OHIO TURNPIKE AND
INFRASTRUCTURE COMMISSION

ADDENDUM NO. 1

PROJECT NO. 39-16-01 (PART A)
RIGHT TWO (2) LANES AND SHOULDER RECONSTRUCTION
MILEPOST 107.3 TO MILEPOST 112.5
ERIE COUNTY, OHIO

PROJECT NO. 39-16-01 (PART B)
BRIDGE DECK REPAIR & REHABILITATION
OHIO TURNPIKE OVER NS RAILROAD AND KELLY ROAD MILEPOST 117.3
OHIO TURNPIKE OVER US ROUTE 250 MILEPOST 118.1
ERIE COUNTY, OHIO

APPROACH SLABS FOR MILL CREEK BRIDGE, WESTBOUND

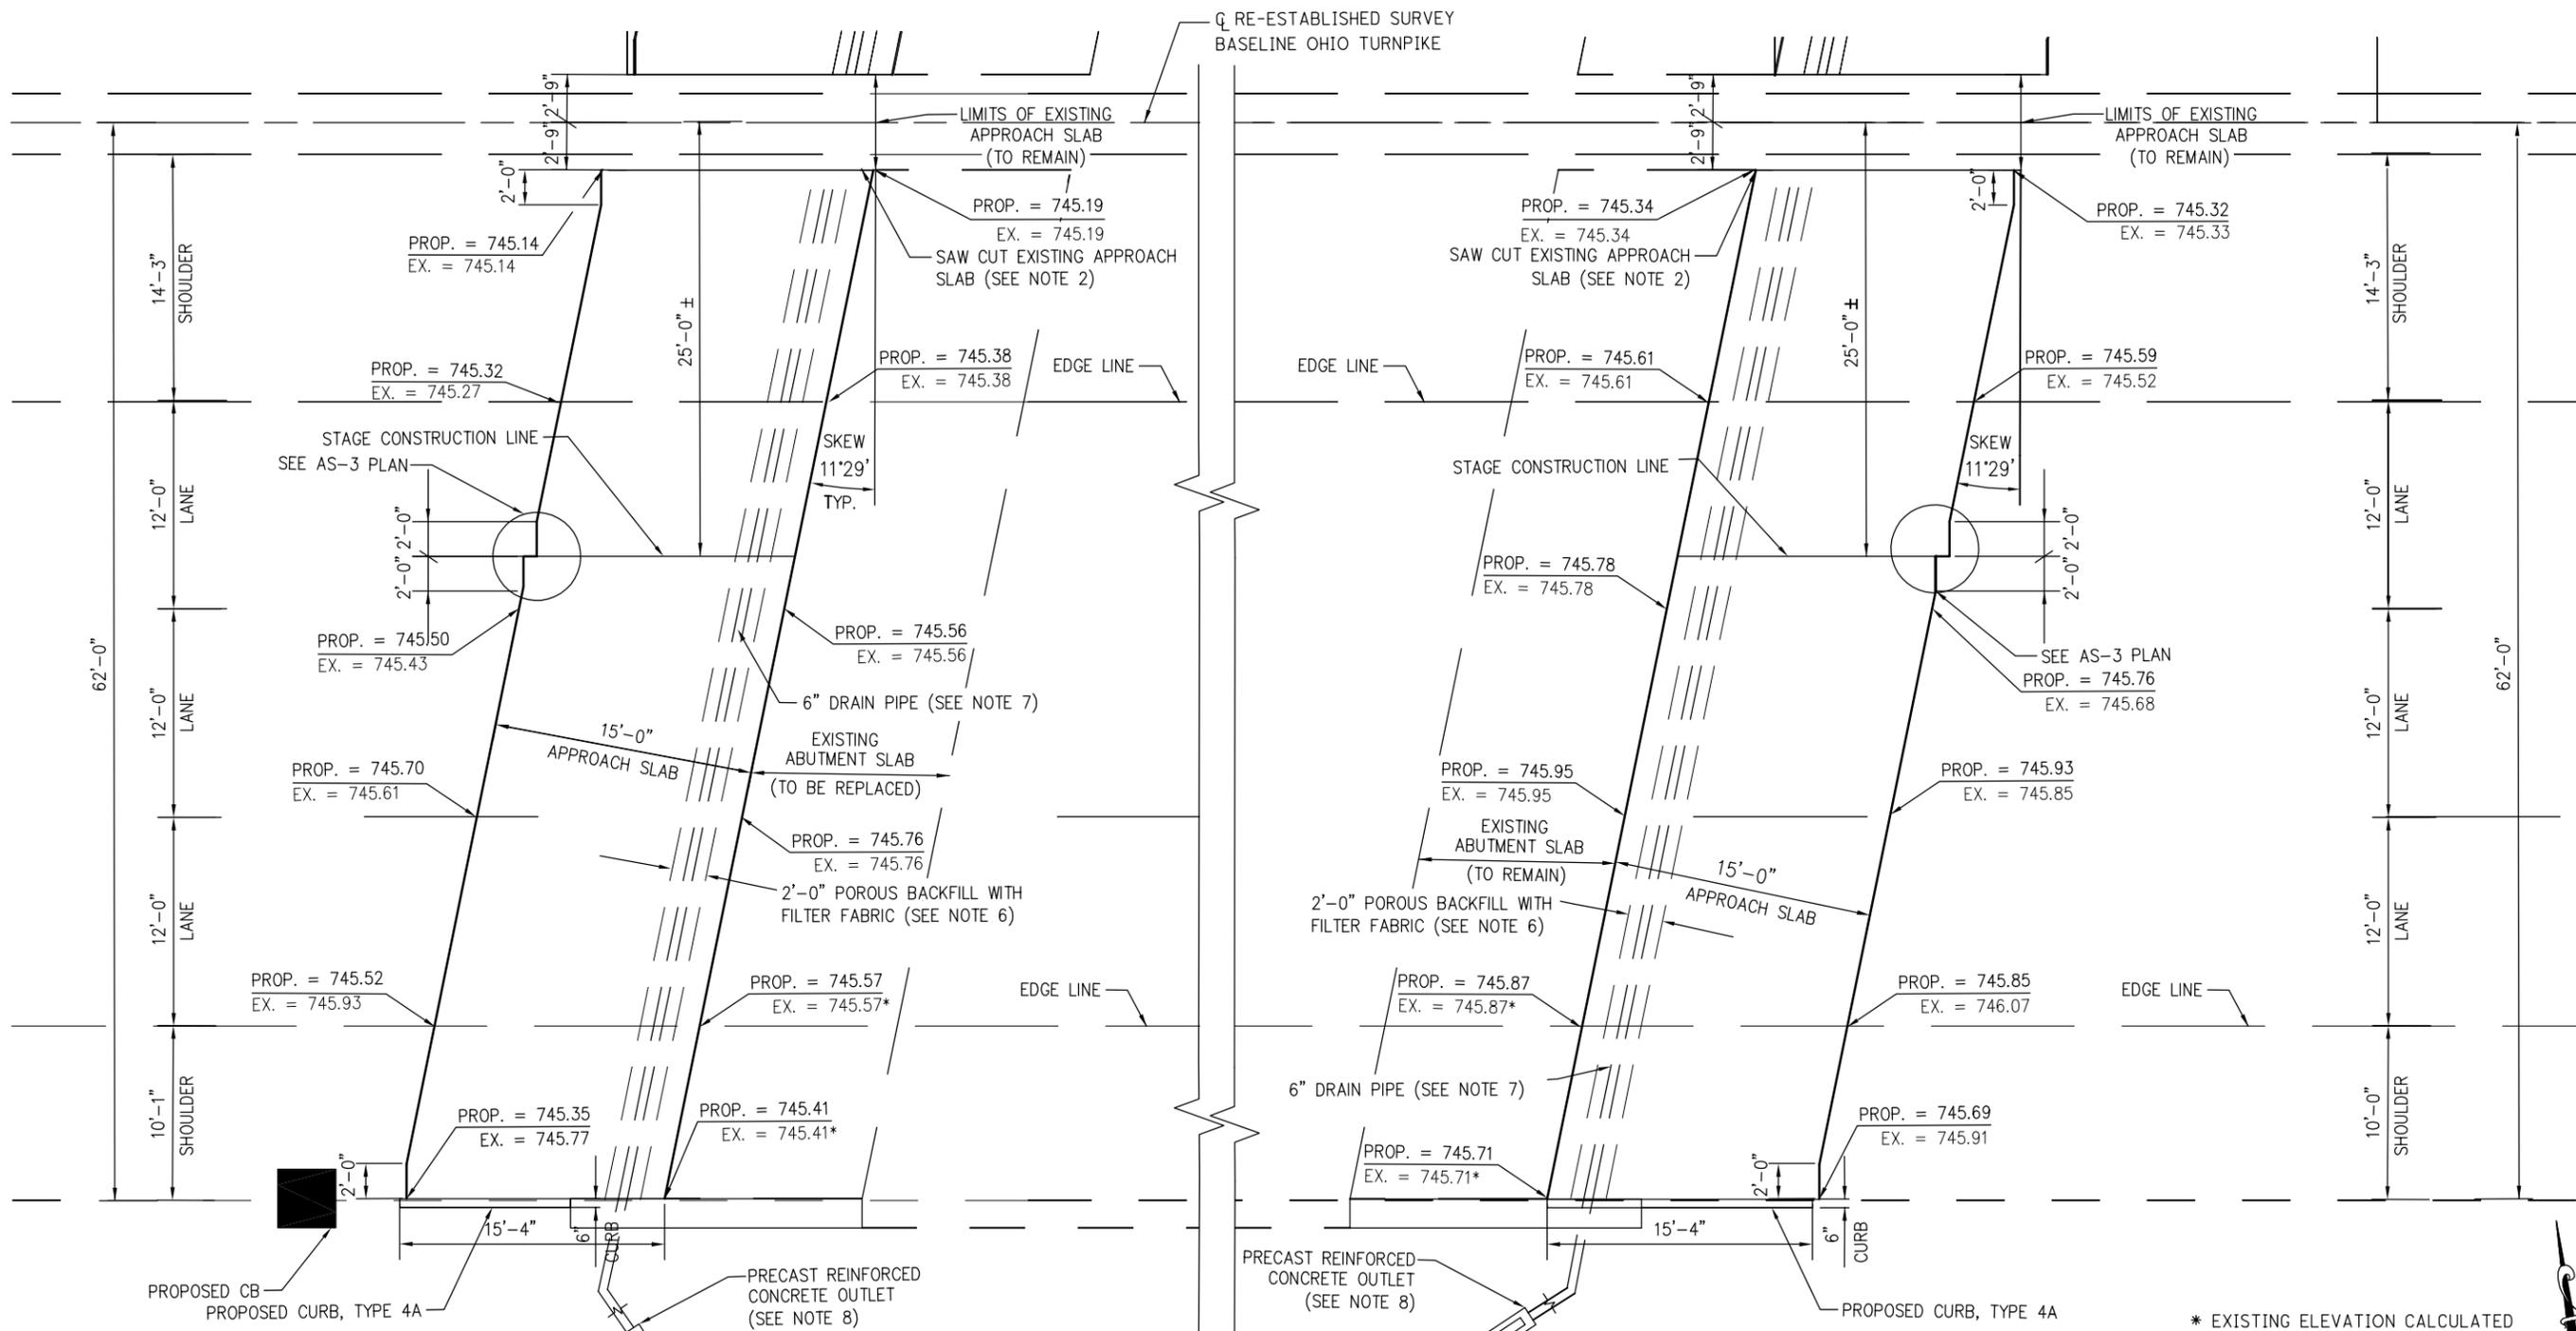
Q#4 Sheets 375-384 - Note 7 shows the installation of a 6" drain pipe per OTIC SD AS-5. Neither the plans, nor AS-5 show the depth of the drain. Please specify drain depth.

Q#5 Sheets 375-384 show the installation of 6" drain pipe per OTIC SD AS-5 directly behind the abutment backwall. However, various locations in the plans call for the installation of a parapet wall that extends behind the backwall and below grade. Can the drain pipe be directed under or around the parapet wall or does the drain pipe need to extend straight through the parapet wall?

A#4 OTIC Standard Drawing AS-5 shows the drain pipe at the bottom of the grade beam. The depth of the grade beam bottom below the approach slab bottom varies. Record OTIC bridge plans for construction completed in the 1950's, 1980's and 1990's within the this project's limits show or scale the following depths: Mill Creek +/- 4'-0" to +/- 4'-6"; NS RR, +/-2'-8" to +/-3'-7"; Portland Road +/-3'-2" to +/-5'-1"; SR 99: +/- 3'-0" to +/- 3"-7".

A#5 The 6" drain pipe is located behind the existing grade beam. The alignment of this 6" drain pipe shall be kept straight behind the grade beam and shall outlet into the embankment slope as shown on Sheets 375 through 384 of 432 of the plans. The Contractor shall drop this drain pipe under the two proposed parapet walls at the Mill Creek bridge, shall drop this drain pipe under the two proposed parapet walls at the NS Railroad bridge and drop this drain pipe under the three proposed parapet walls at the SR 99 bridge. There are no conflicts with this drain pipe at the Portland Road Bridge

ABUTMENT PLAN

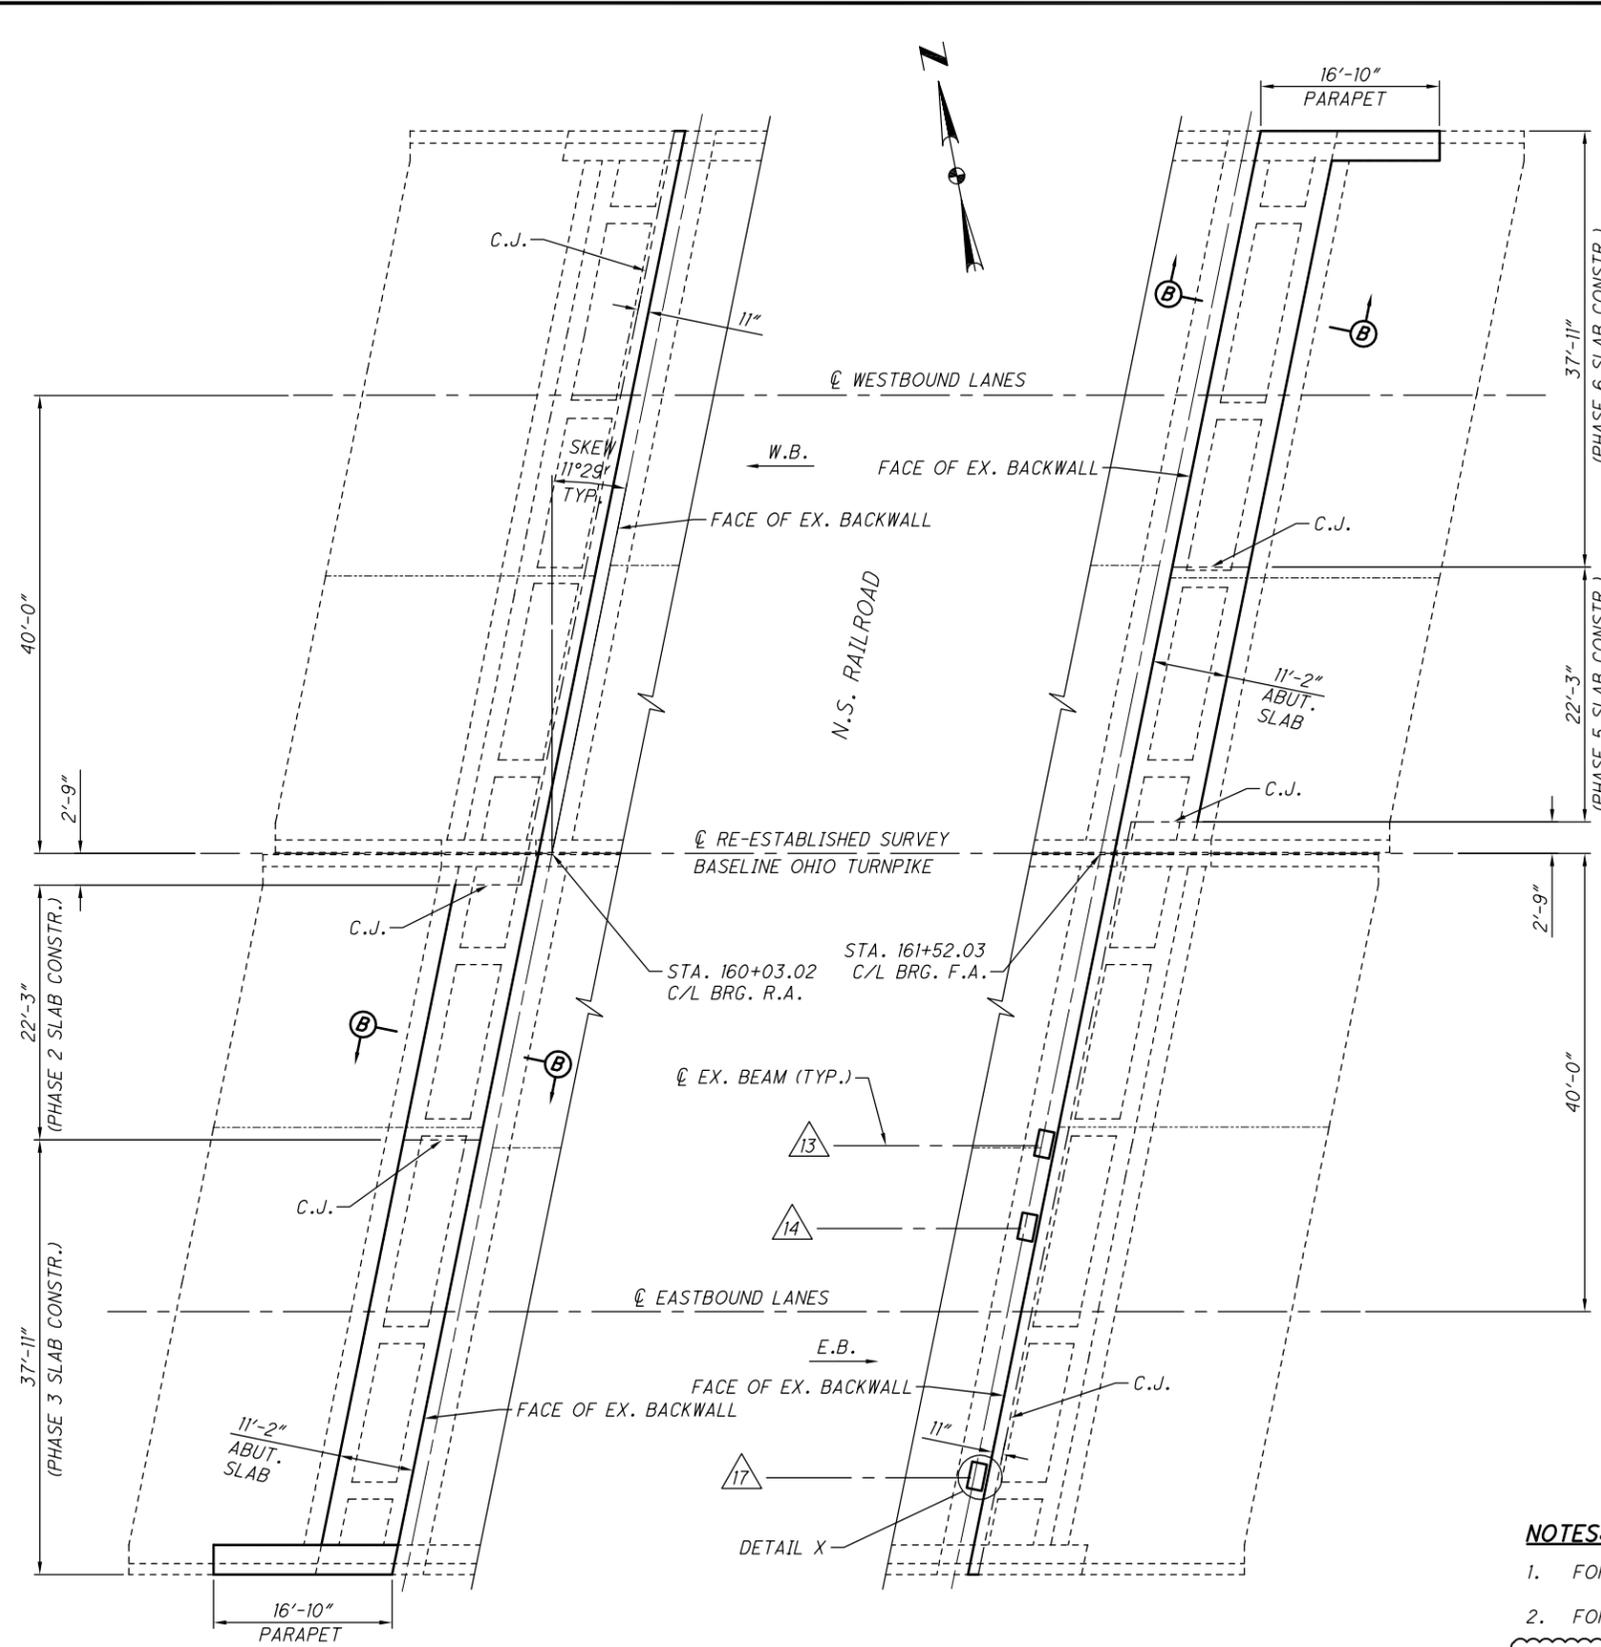
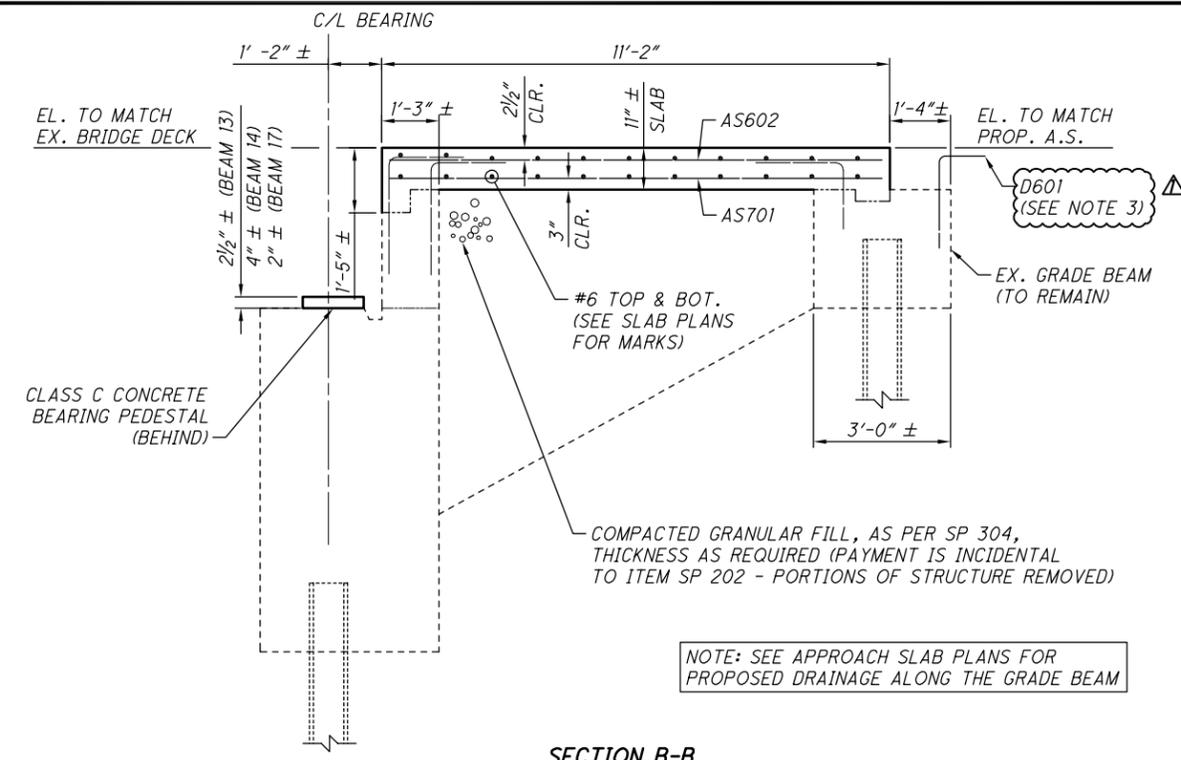
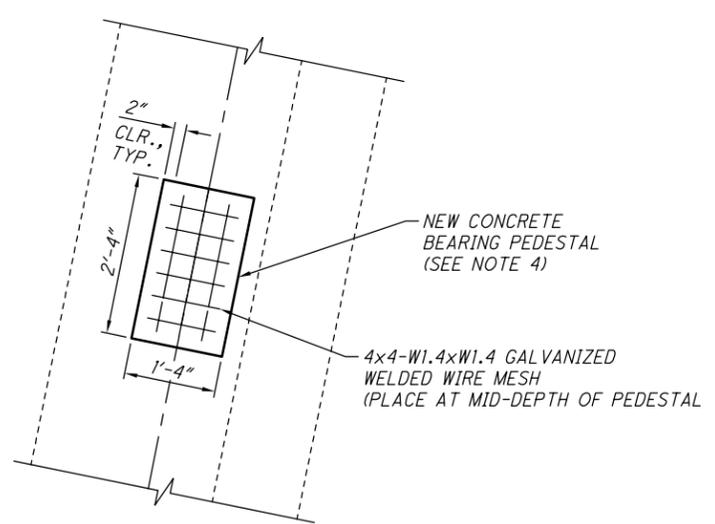
Q#3 Sheets 405,411,417,425 call for D801 Approach Dowels Per Note 3. Is the intent of this bar to replace the #6 bars called out on OTIC SD AS-5 Note 5? Please define spacing of D801 bars and #6 bars to be installed. Also, please clarify how the doweling of the D801 bars are to be paid.

A#3 Through this Addendum No.1, the specifications for D801 bars are deleted and replaced with D601 bars and the spacing of these D601 bars to agree with OTIC Standard Drawing AS-5. Plan notes and Plan callouts have been modified on Sheets 375 through 384 of 432 and Sheets 405, 406, 407, 409, 411, 412, 413, 415, 417, 418, 419, 420, 421, 423, 425, 426, 427 and 431 of 432 to substitute D601 for D801 bars. The cost of the dowel holes and D601 bars are incidental to SP526 – Approach Slab, As Per Plan therefore quantities for Item 510 – Dowel Holes with Non-shrink, Non-Metallic Grout and SP 509 – Epoxy Coated Reinforcing Steel, As Per Plan have been reduced on Sheets 391 through 394 of 432.

1. FOR ABUTMENT SLAB REMOVAL DETAILS, SEE SHEET 1 OF 6.
2. FOR REINFORCING BAR PLACEMENT DETAILS, SEE SHEET 3 & 4 OF 6.
3. INSTALL D601 APPROACH SLAB DOWELS PER C&MS 510. PLACE DOWEL WITH NON-SHRINK, NON-METALLIC GROUT. DRILL DOWEL HOLES 4" (MIN.) CLEAR OF GRADE BEAM'S EDGE AND 12" DEEP. DOWEL HOLES COST IS INCIDENTAL TO THE COST OF SP 526 - APPROACH SLAB. D601 COST IS INCLUDED UNDER SP 509 - EPOXY COATED REINFORCING STEEL, AS PER PLAN.
4. PAYMENT FOR REPLACING CONCRETE BEARING PEDESTALS IS UNDER ITEM 511 - CONCRETE MISC.: REPLACE EXISTING CONCRETE BEARING PEDESTAL. SEE THE ITEM 511 GENERAL NOTE FOR ADDITIONAL INFORMATION.
